**COAL ASH IMPOUNDMENT
SITE ASSESSMENT FINAL REPORT**

**Marion Power Station
Southern Illinois Power Cooperative
Marion, Illinois**

KLEINFELDER PROJECT NUMBER 118953-5

February 28, 2013

Photo 14 – Ash Pond 1 General Conditions Photograph (Note Inlet Sluice Pipe)
May 25, 2011 IL50160

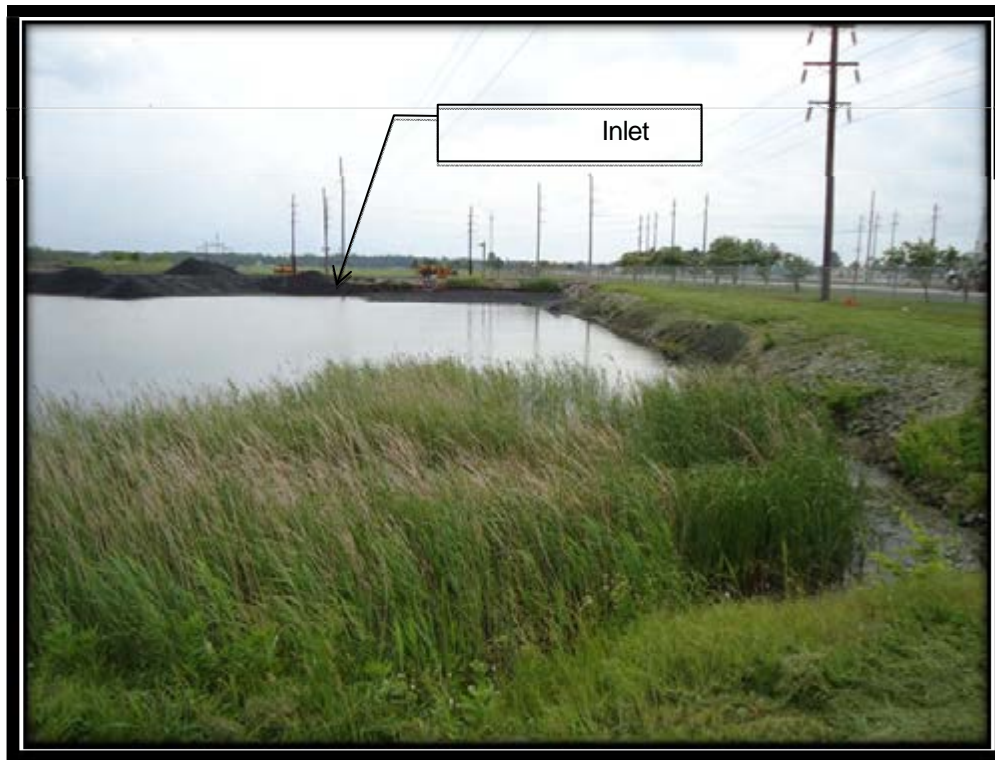
Overall, the upstream slope of the impoundment was in fair condition. Photos 11, 12, 14 and 15 in Appendix B show the conditions of the upstream slope. Figure 4 displays the location of where these photographs were taken during the assessment. Specific observations include:

Photo 16 – Ash Pond 1 Upper Discharge Pipe into Pond 4

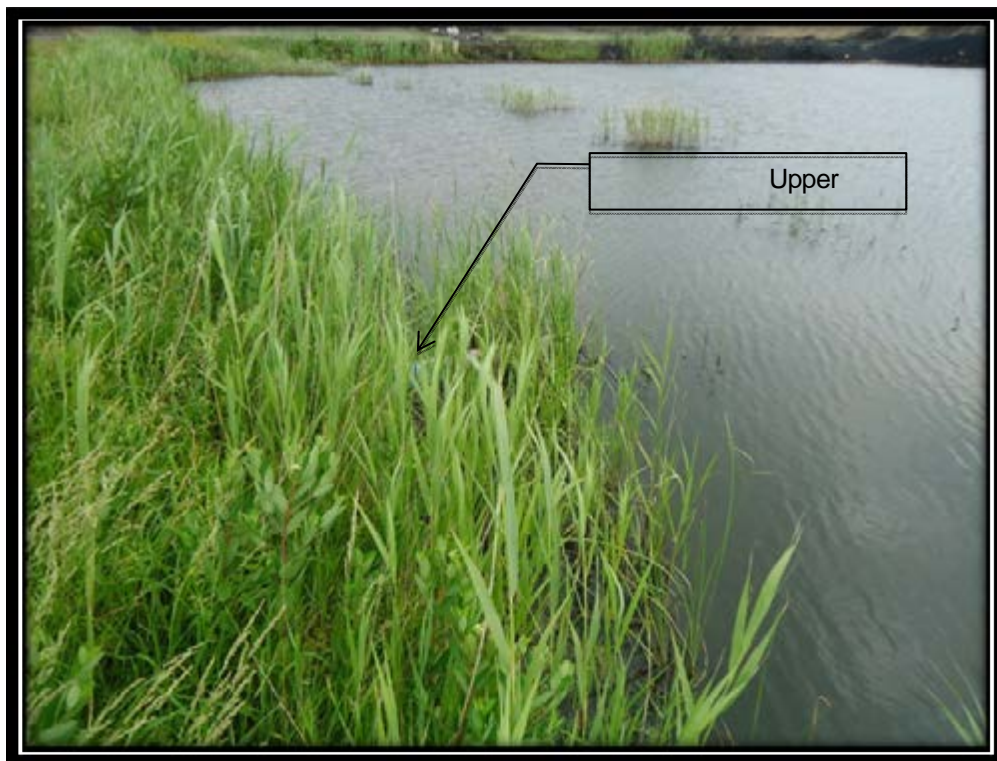
Overall, the crest of the impoundment was in satisfactory condition. Photos 12 and 15 show the condition of the crest. Specific observations include:

BURNS AND McDONNELL ENGINEERING CO. - PONDS 1 & 2 BOTTOM ASH PLAN & ELEVATION- SHEET 30 - 07/05/62

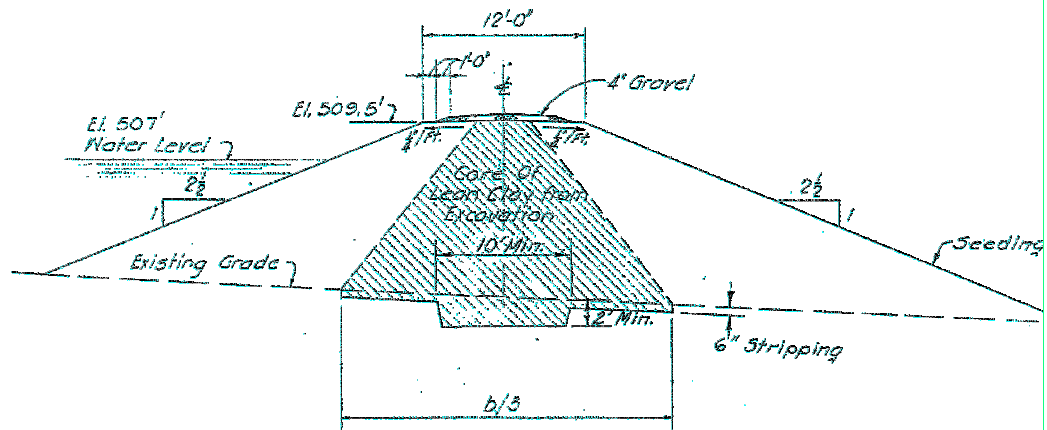
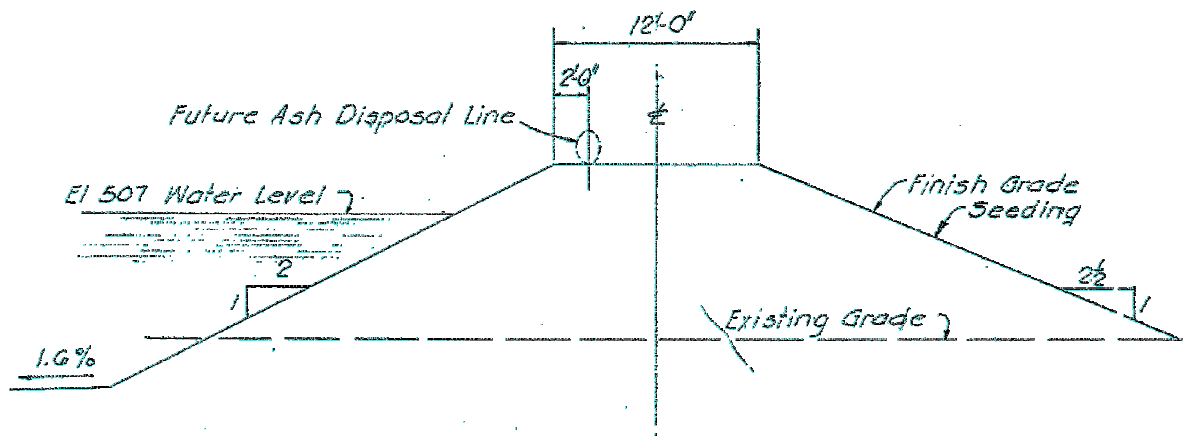
- The upstream slope was laid back at approximately 2H:1V to 2.5H:1V based on visual observations. These observations are consistent with the design drawings that were provided by Southern Illinois Power Cooperative.
- Bottom ash cleanout operations had created bottom ash stockpiles against the upstream slope of the pond in some locations. However, these cleanout operations did not appear to have disturbed the original slopes of the impoundment.
- Vegetated riprap was present in various locations, but did not appear around the entire perimeter of the pond.
- Minor erosion rills, less than 6 inches deep, were noted on some of the upstream slopes.
- Grasses, woody bushes and reeds were observed on the upstream slope for the majority of the impoundment.
